NRL/MR/7441--94-7516

Digital Mapping, Charting, and Geodesy Analysis Program Technical Review of Vector Smart Map Prototypes 1 and 2

January 19, 1995

Figure 1. Hess grass runway described as major airfield in VPFVIEW query

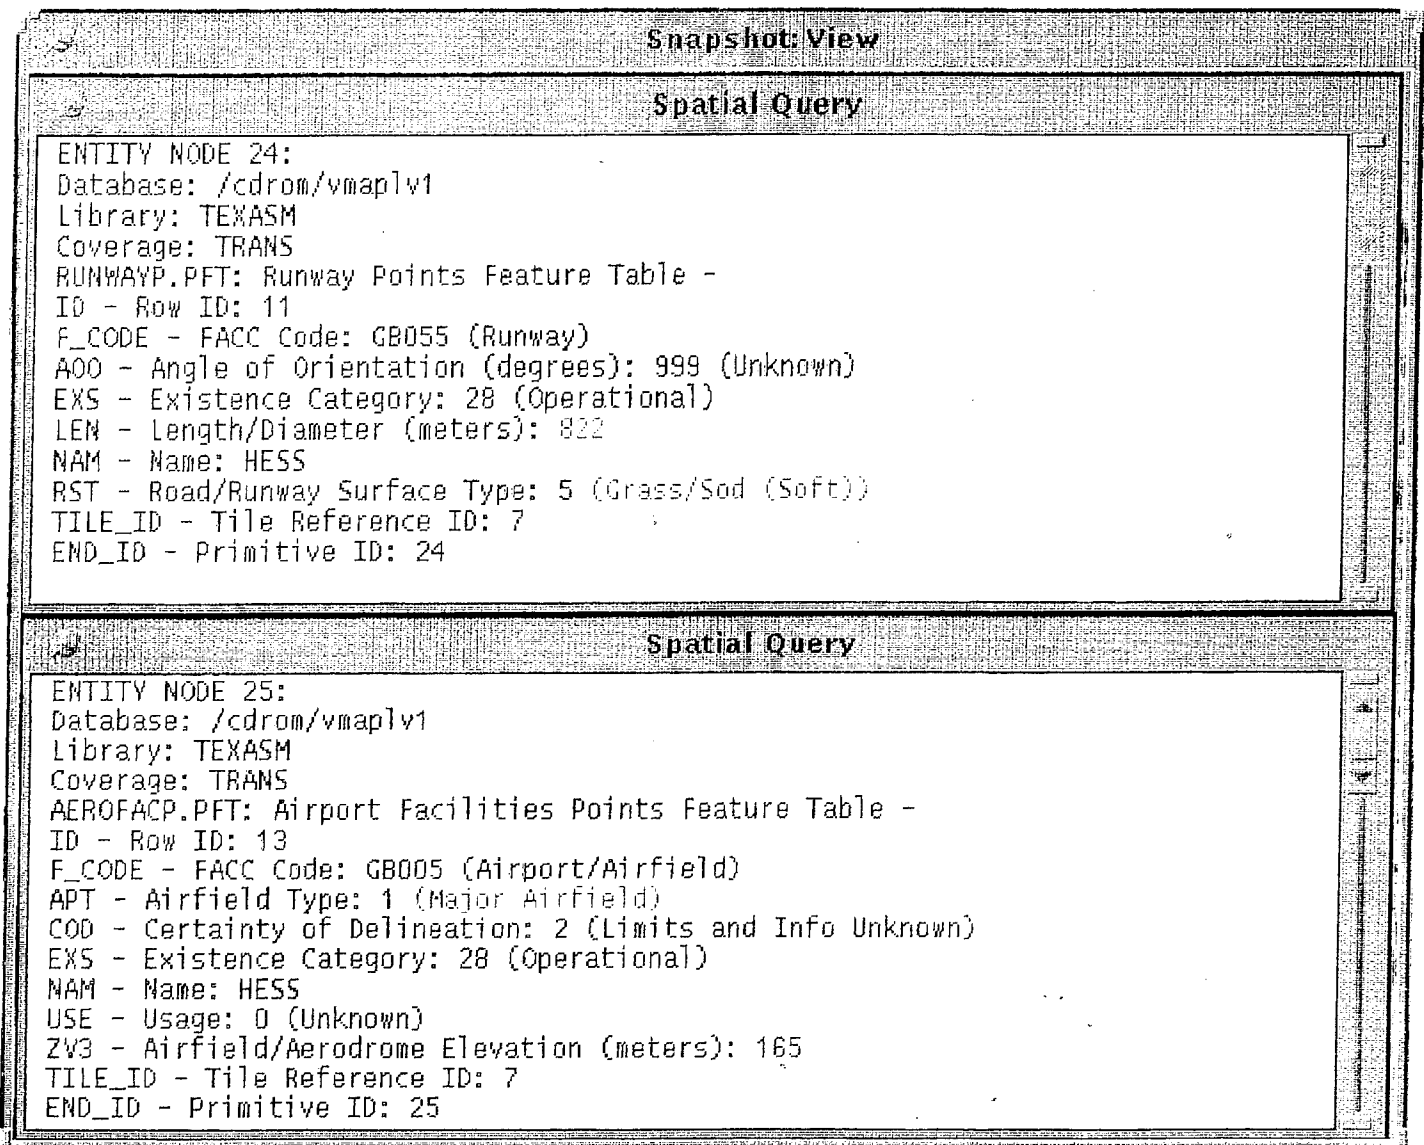
Examples of data errors contained in the medium resolution database of Texas are provided in the following figures. Figure 1 shows the results of a spatial query performed on an airport near the city of Waco. Hess runway, in the Transportation coverage, is described as operational, 822 m in length, with a grass/sod (soft) surface type. However, the associated airport, also in the Transportation coverage, is described as a Major Airfield, i.e., attribute APT, Airfield Type, is 1. In V_{Map} the possible values for APT are limited in the sense that "Minor Airfield" or a similar descriptive term is not a possibility. The only possible values for APT are 0 (Unknown), 1 (Major Airfield), 3 (Undefined Landing Area), and 9 (Heliport). (Note: According to the FACC, the value 2 for APT indicates a "Minor Airfield.")

Figure 2b. Data content errors in railroad

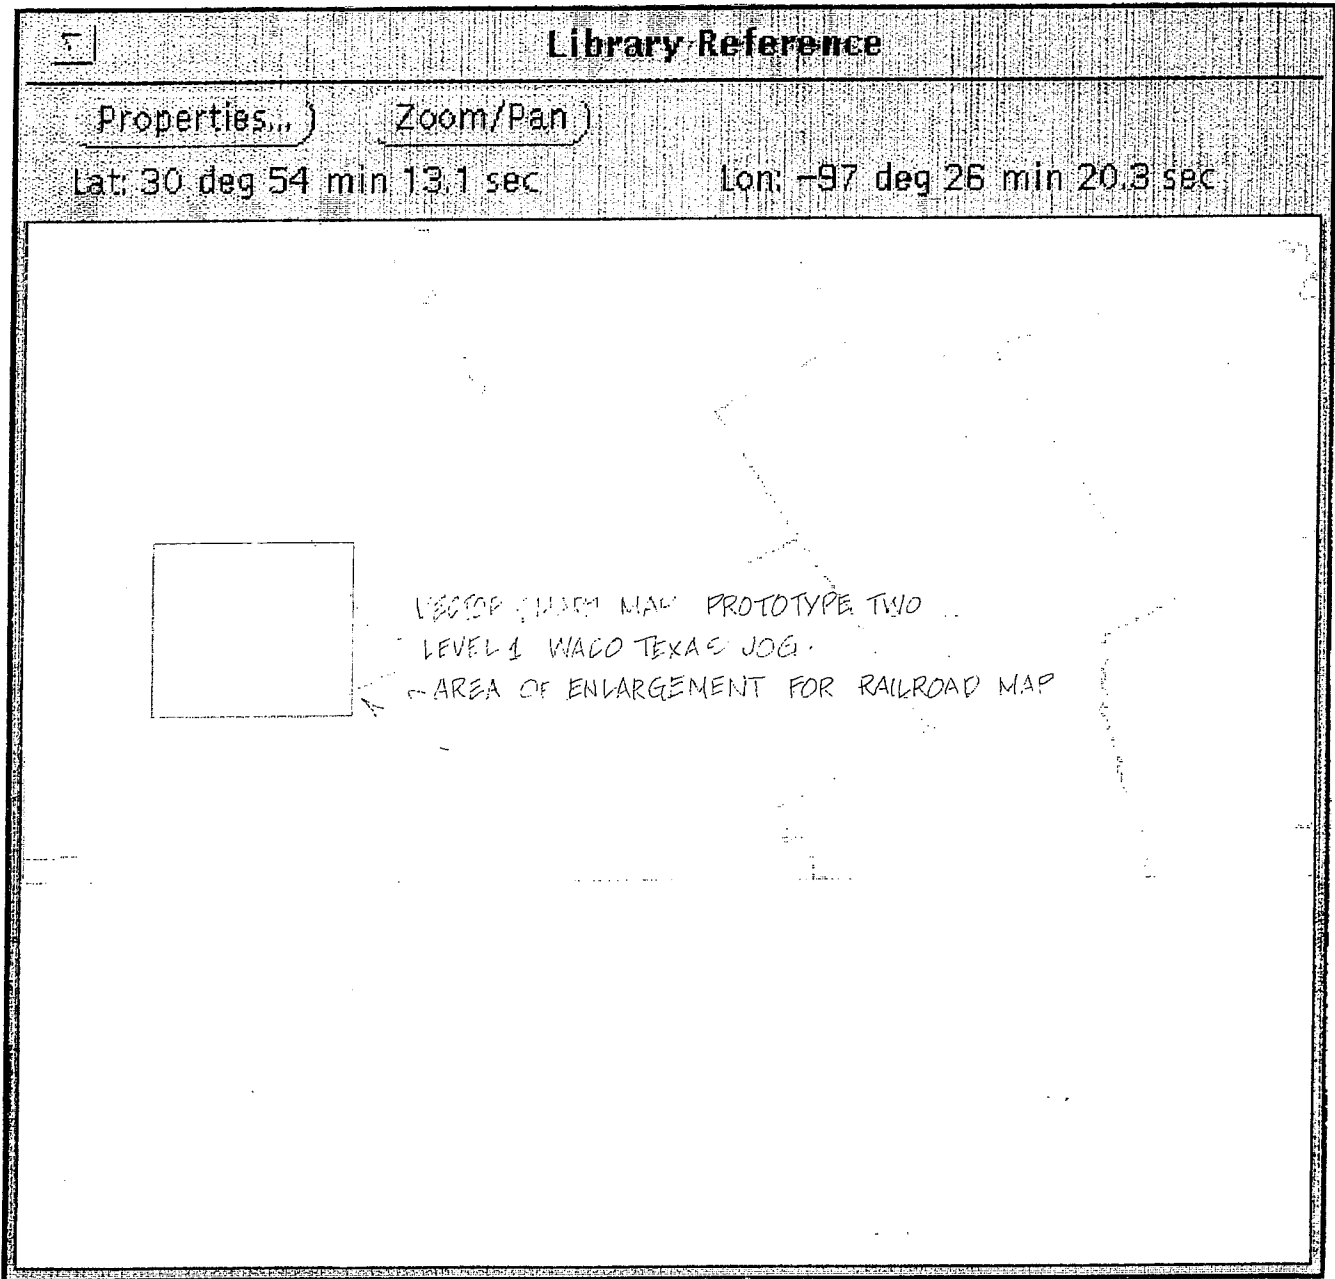
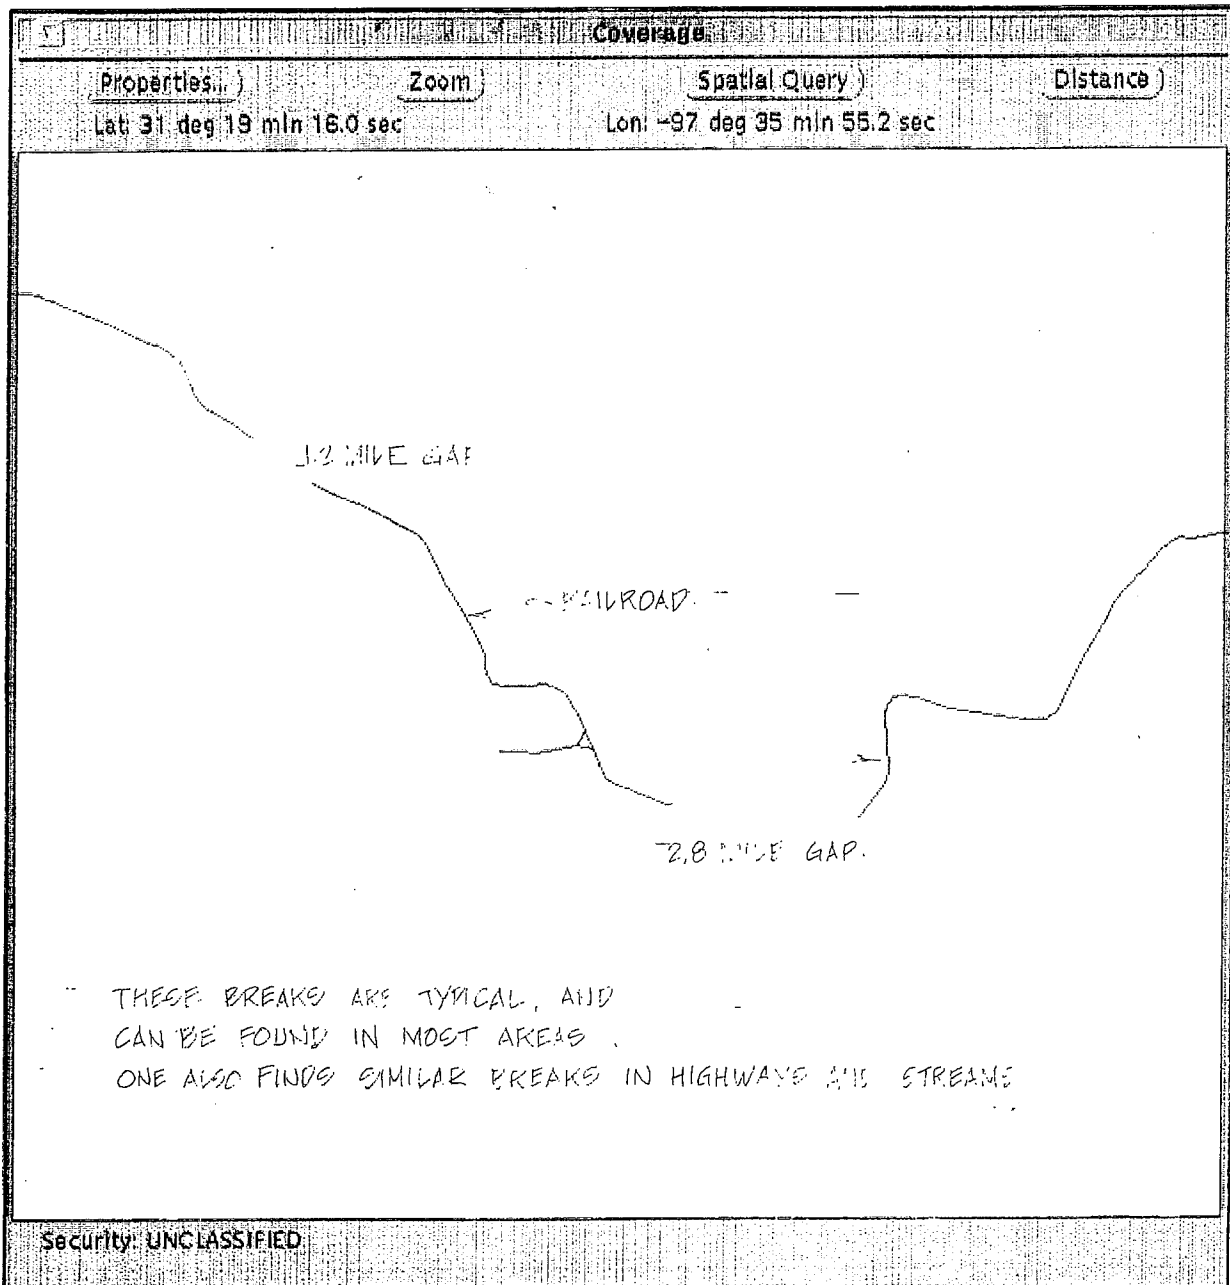
Figures 2a and 2b display an area near Waco and an associated railroad in the Transportation coverage. Unusually large "gaps" are present in the data and could be a result of faulty digitization. Data omission errors and improper registration are displayed in Figures 3 through 5. The circled items in Figure 3 show incomplete "pieces" of roads and data omissions of the railroad in places where a railroad and road are in close proximity. In Figure 4, water courses have clear data omissions. Figure 5 shows apparent shifts in geographical position between the Hydrography and Transportation coverages.

Figure 6a. "Missing" river/political boundary in hydrography coverage

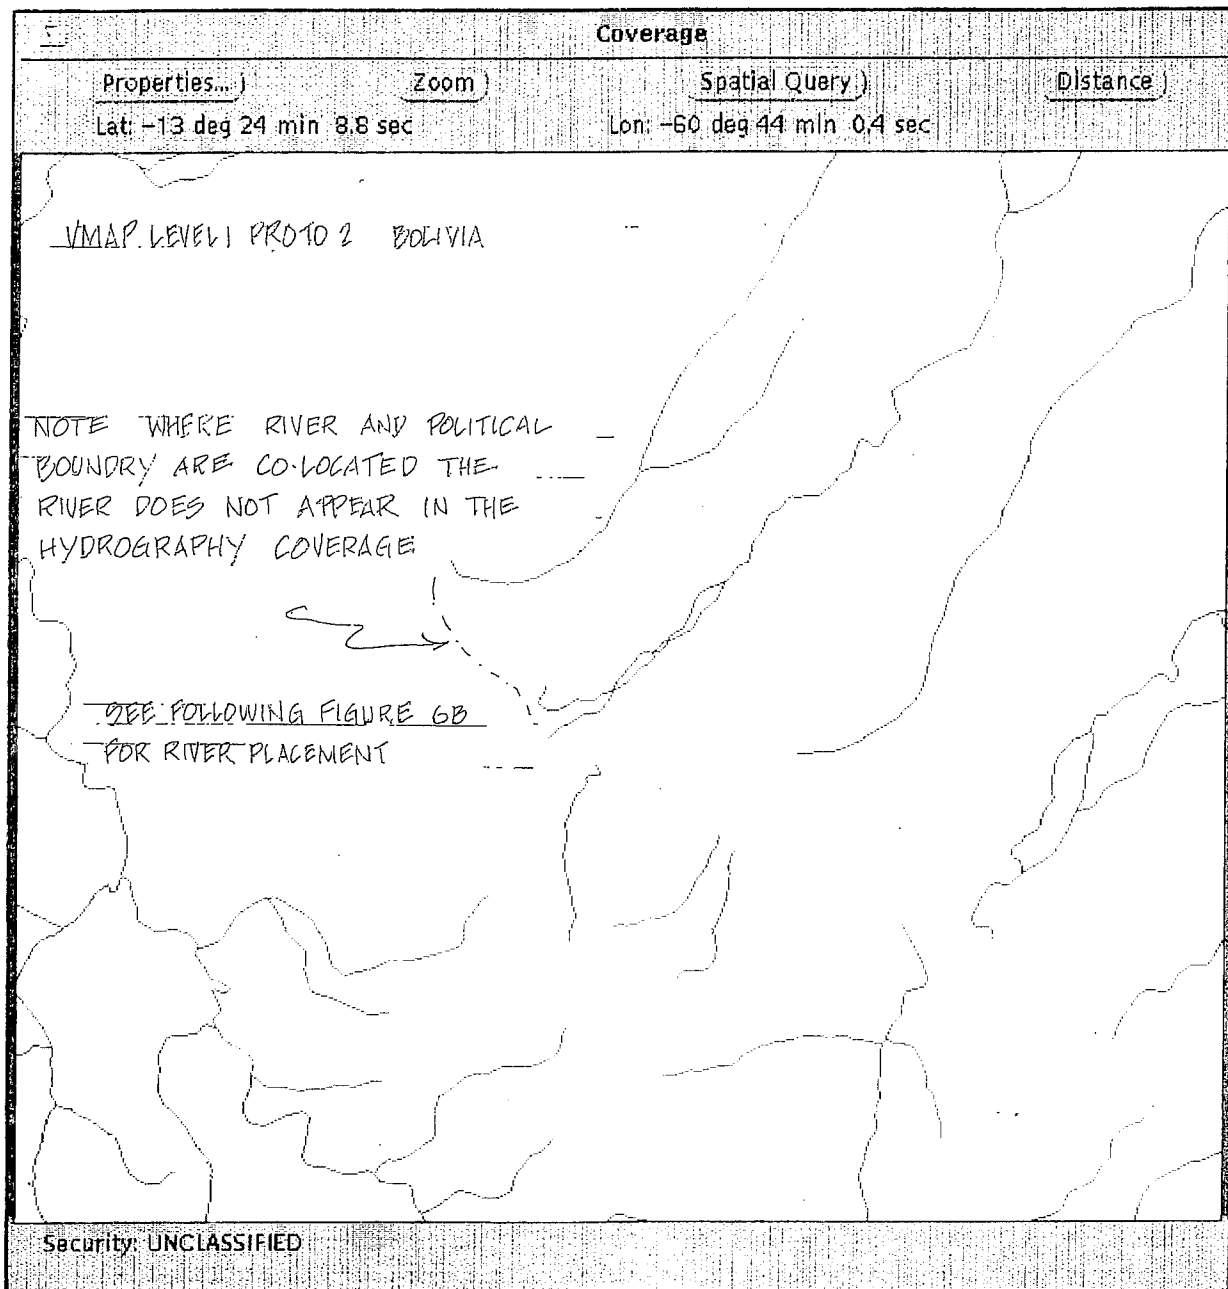
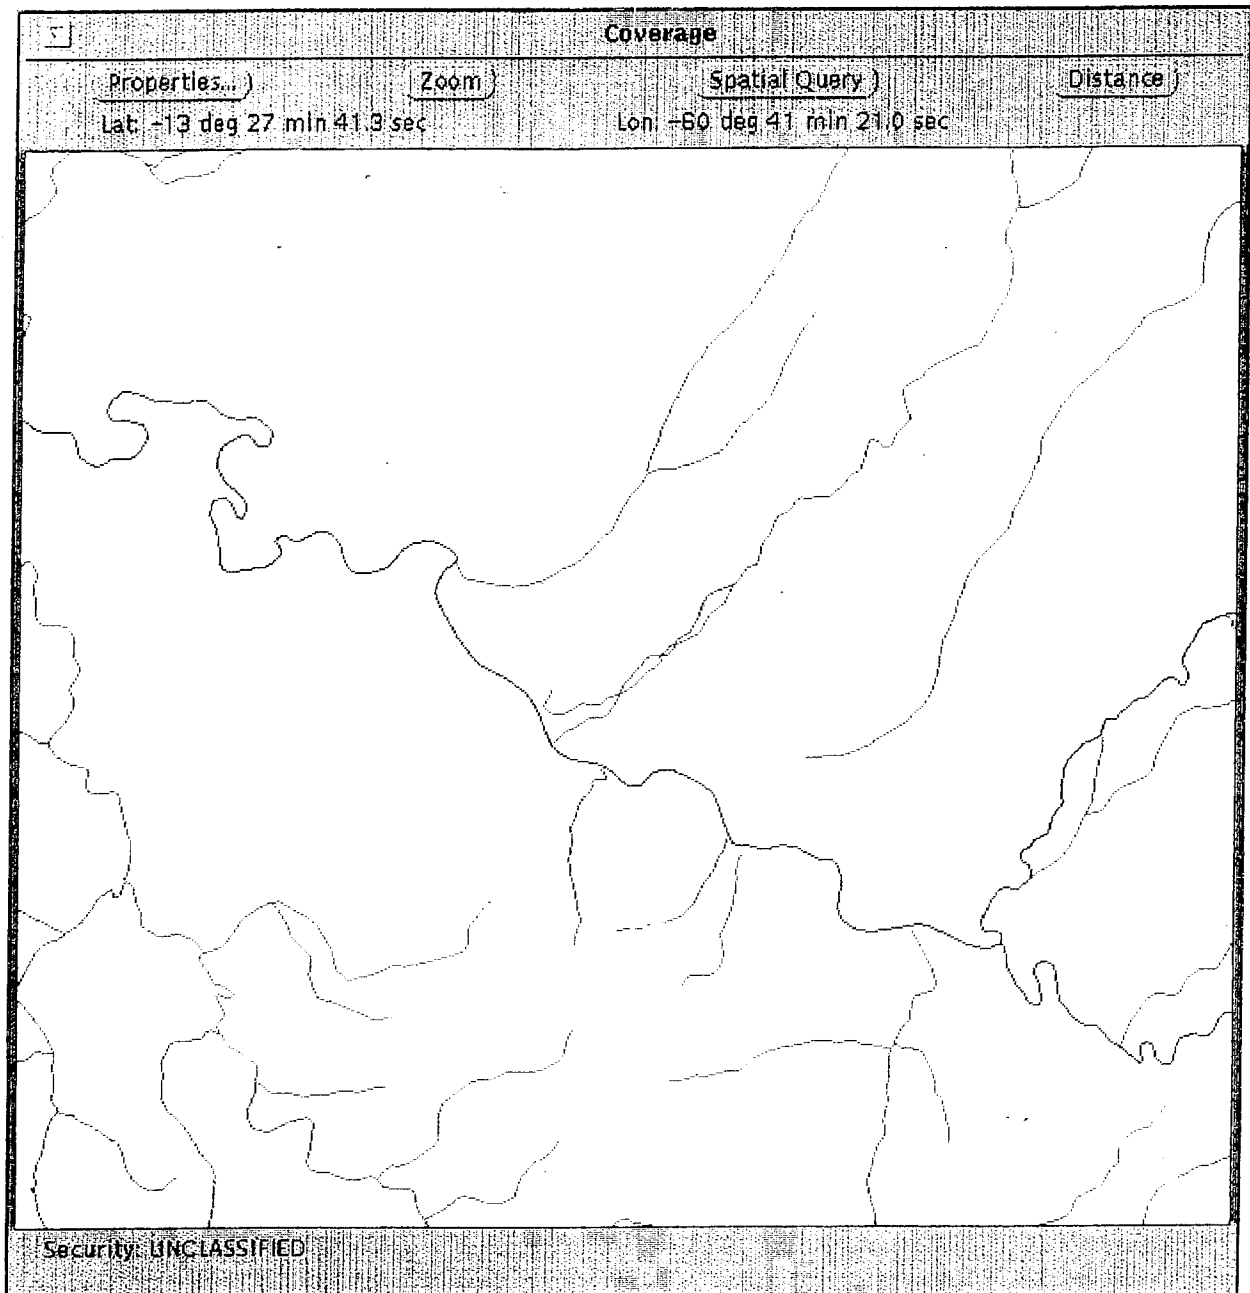
Figures 6a and 6b display water courses from the Hydrography coverage of the medium resolution Bolivia database. The Boundaries coverage political boundary line, between Bolivia and Brazil is determined by a river. This river is not recorded in the Hydrography coverage where one would expect, which caused some confusion. However, upon further study, the river was located in the *area* feature class Water Courses and Bodies in the Hydrography coverage.

Figure 8 Water courses with apparent gaps

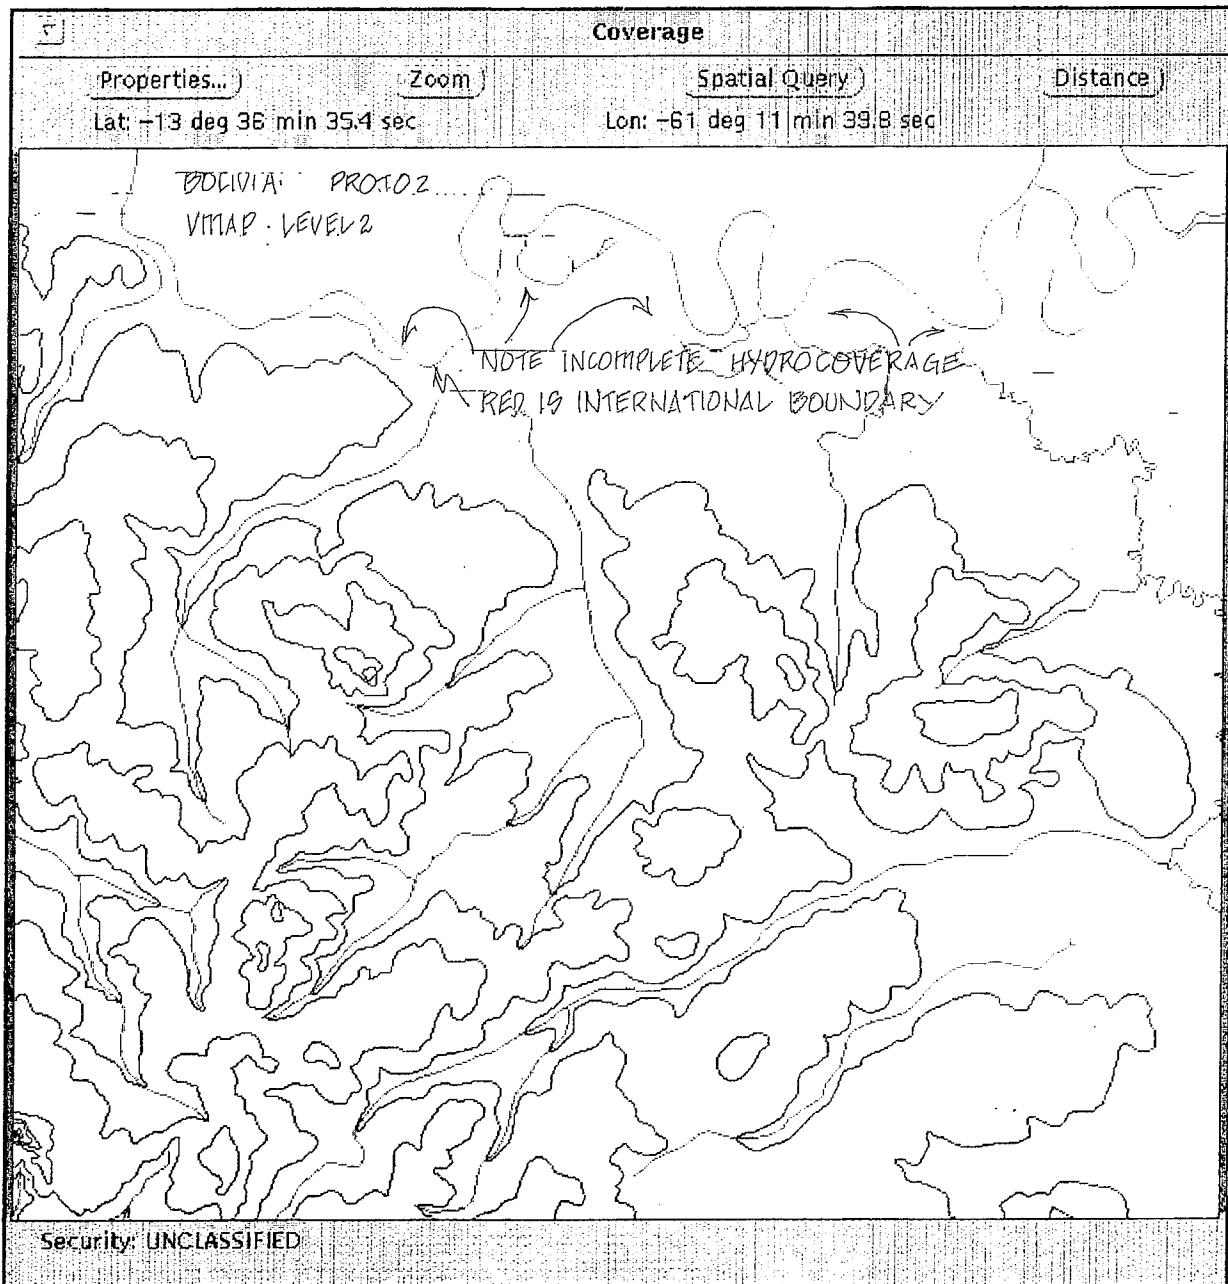
Figure 8 displays the water courses in the Hydrography coverage and political boundaries in the Boundaries coverage of the high resolution Bolivia data. Similar to the Level 1 Bolivia database, confusion resulted near the boundary. Water courses appear incomplete, when in actuality the area feature class Water Courses and Bodies "fill-in" the gaps.

Figure 9a. Construction of a query using Microsoft Access QBE editor

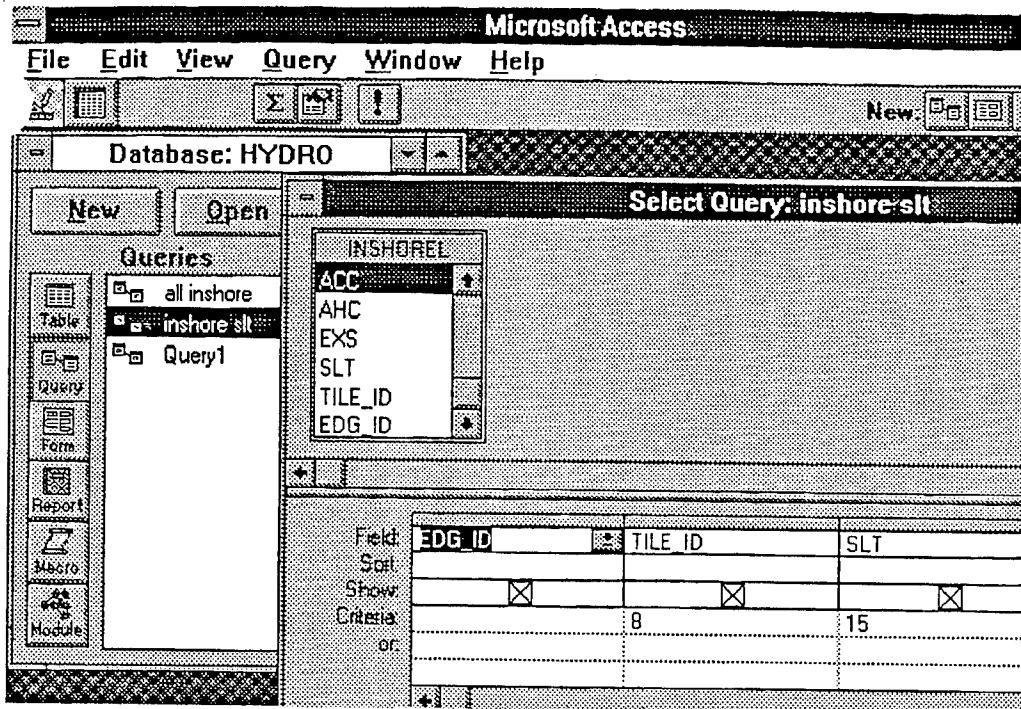
Figure 9a shows the construction of a query using Microsoft Access Query By Example (QBE) editor. The query accesses a single table, the Inland Shore Line Feature Table in the Hydrography Coverage, and is designed to list the EDG_IDs that are in TILE_ID 8 that have a Shoreline Type Category of "Other" (attribute value 15). Figure 9b is the spreadsheet view of the result of the query. It was noted that all of the rows in this table have a value of "Other" in the Shoreline Type Category. If none of the shorelines fit any of the categories, then either the categories are poorly chosen or the data were carelessly produced.
